CERTIFICATE OF APPROPRIATENESS

Property: 1636 South Boulevard, Lot 13, Block 3, Edgemont Subdivision. The property includes a historic 3725 square foot two-story brick single-family residence and detached garage situated on a 15,980 square foot (94' x 170') interior lot.

Proposal: Alteration – Revision. In February 2014, the applicant was granted permission to construct a new carport and a front facing brick arched vehicular entrance gate at the west side of the residence.

The applicant proposes to revise the design of the carport and front facing brick arched vehicular entrance gate at the west side of the residence.

ROOF PLAN

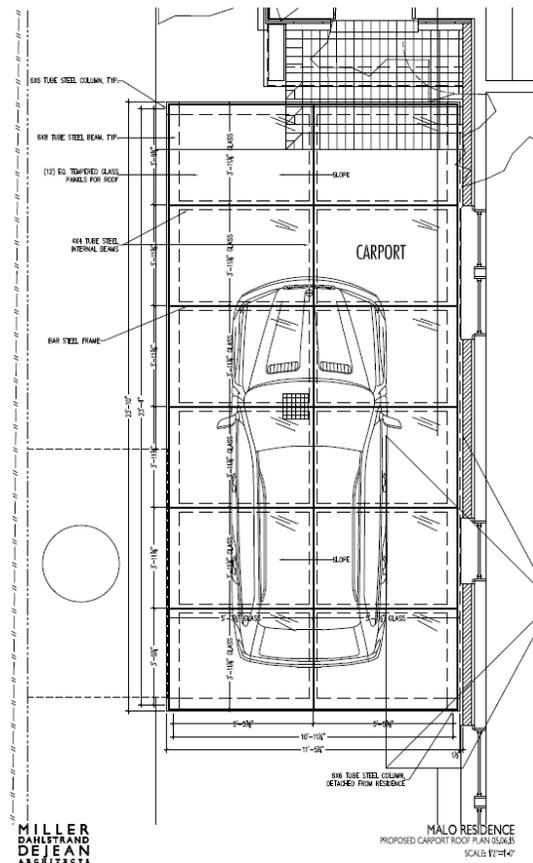
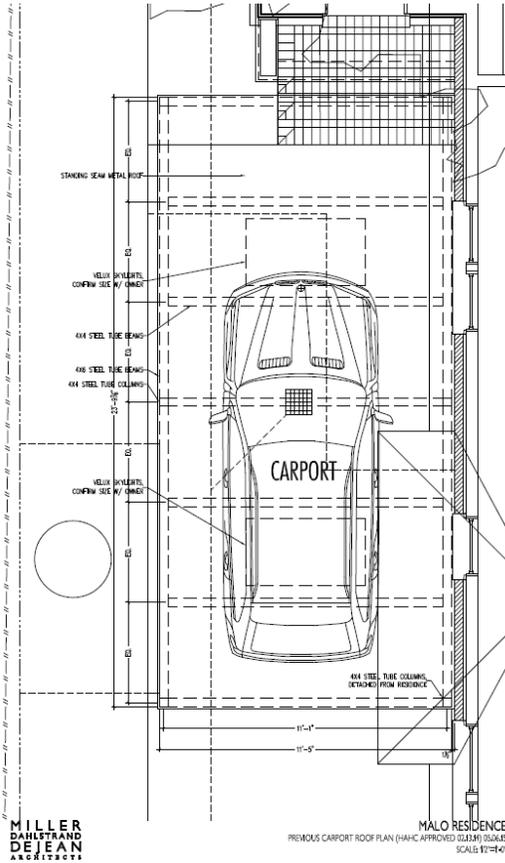
- The carport roof will now be comprised of 12 tempered glass panels instead of the approved standing seam metal roof with two skylights
- The previously approved footprint of the carport will not be altered, but decorative metal trim will be removed
- The proposed brick arch vehicular entrance will be revised to no longer incorporate an archway. The gate will now be attached to a portion of the existing buttress.

Carport: Revisions to the carport include altering the previously approved 6 panel standing seam metal roof with two skylights to a 12 panel tempered glass roof. Carport will maintain its steel frame. The decorative wrought iron work has also been eliminated. Gutters and downspouts and size to remain the same. It still remains detached from the existing house. See drawings for more detail.

GATE ATTACHMENT DETAIL

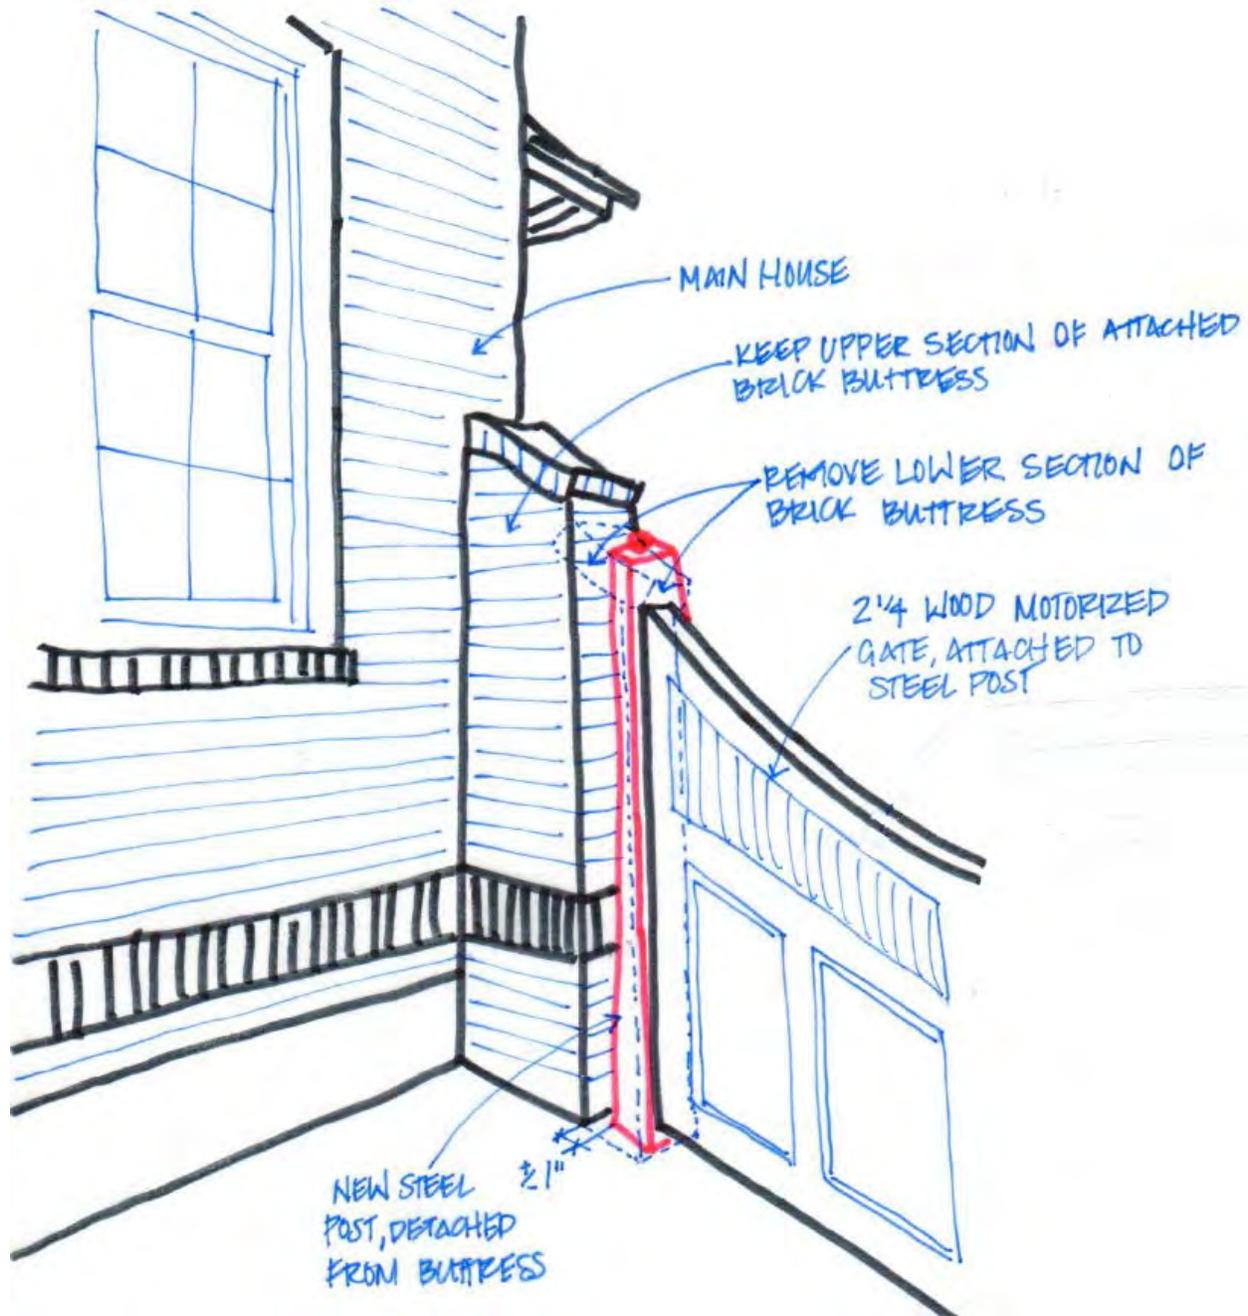
Entry Gate: The previously approved entry gate will be revised and will no longer include the brick arch. As currently proposed, a lower section of the brick buttress attached to the house will be removed and a steel post and wood gate will be installed, both detached from the buttress. The steel post will be installed 1" from the remaining portion of the buttress. The total width of the gate will be 9'-0" (with a width of 9'-10" including the posts). The wood gate will have a 'U' shape design with a maximum height of 6'-6½" and a minimum height of 5'-5". A 7'-9" brick wall will extend from the wood gate to an existing brick column. The brick wall will have a maximum height of 8'-0" and a minimum height of 7'-2". The brick wall will be 1'-0" thick. See drawings for more detail.

Proposed Alterations: Entry Gate: The proposed brick arch vehicular entrance will be revised to no longer incorporate an archway. The gate will now be attached to a portion of the existing buttress and will now include a lower brick wall with motorized wood entrance gate. The tallest part of the fence will be no more than 8'-0" in height. New brick wall to match existing details from attached wing wall. See drawings for more detail.
